**RESPONSE TO NRC QUESTIONS ON STEAM GENERATOR TUBE INSPECTION**

**PREPARED BY FLORIDA POWER AND LIGHT COMPANY**

**ST. LUCIE UNIT 2 - DOCKET NO. 50-389**

Reference: NRC letter dated April 8, 2003, Saint Lucie Nuclear Plant, Unit 2:  
Upcoming Steam Generator Tube Inservice Inspection (TAC No. MB81 34)

**Axial ODSCC at Eggcrates Screening Limits - PSL-2 SG A**

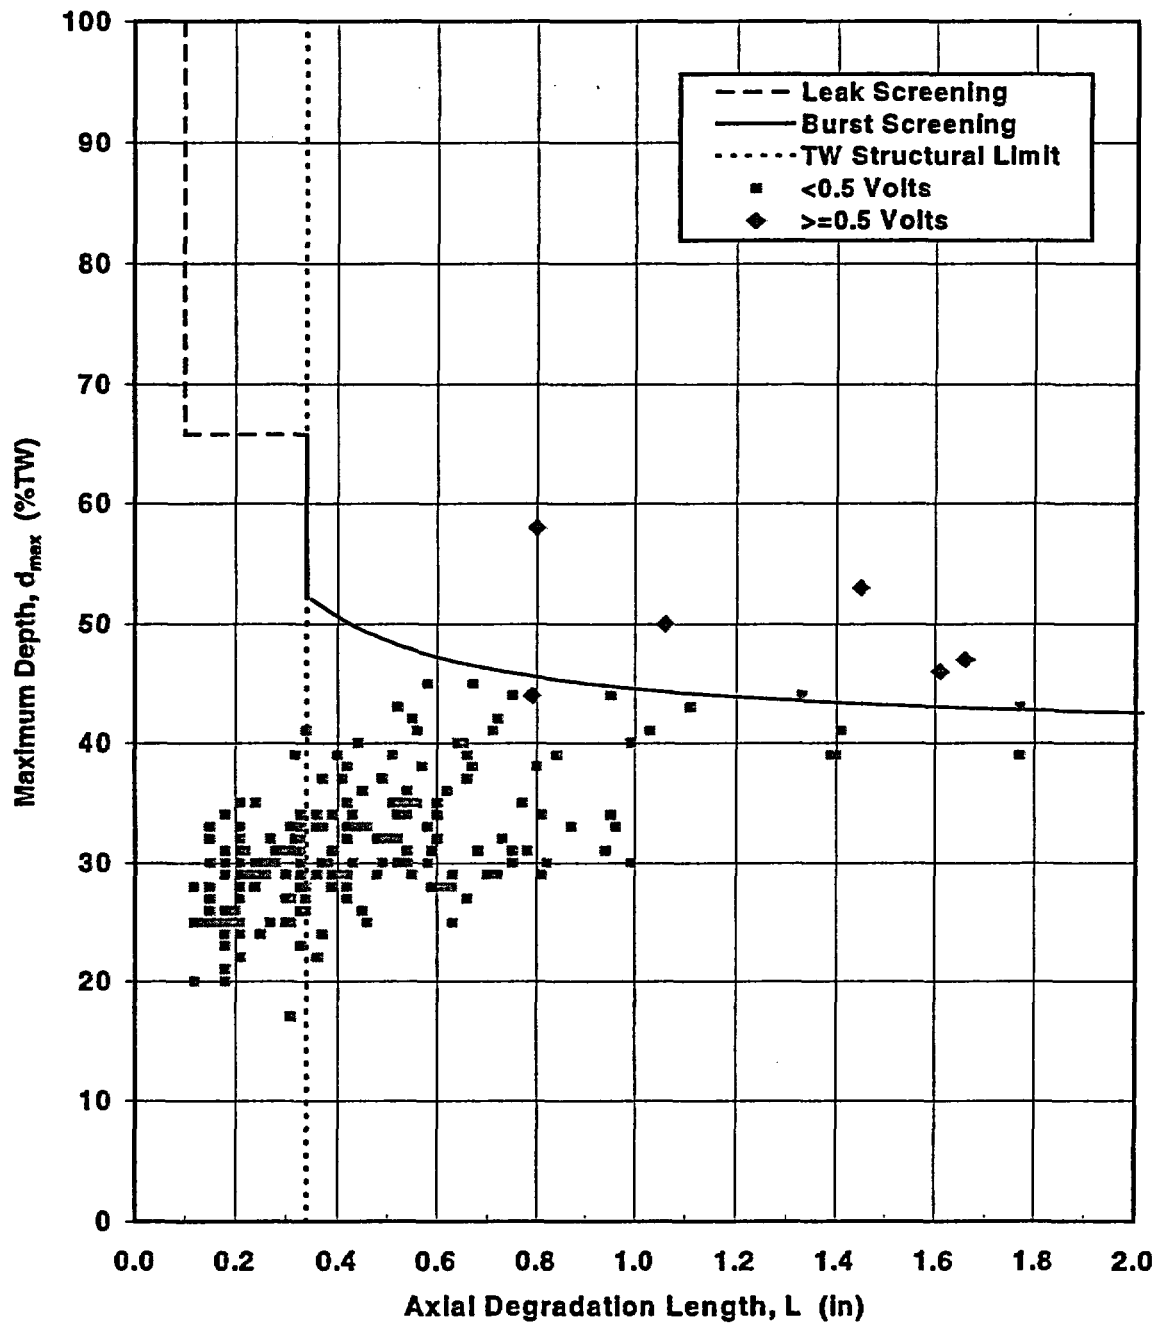
5. Provide a summary of the number of indications identified to-date of each degradation mode and SG tube location (e.g., tube support plate, top-of-tubesheet, etc.). Also provide information, such as voltages, and estimated depths and lengths of the most significant indications.

Initial in situ screening plots are provided for indications reported in the April 2003 inspection to provide a perspective on estimated length, depth and voltage. This initial screening is conservative in that the flaw is modeled by a bounding geometric shape. For example, a circumferential indication is treated as a rectangular-shaped crack where the maximum depth is assumed over the entire flaw length. Flaws exceeding the screening criteria are further evaluated with detailed plus point profiles and structural evaluations are then completed to determine if these flaws require in situ testing. For the flaws evaluated to date, none require in situ testing based on these evaluations.
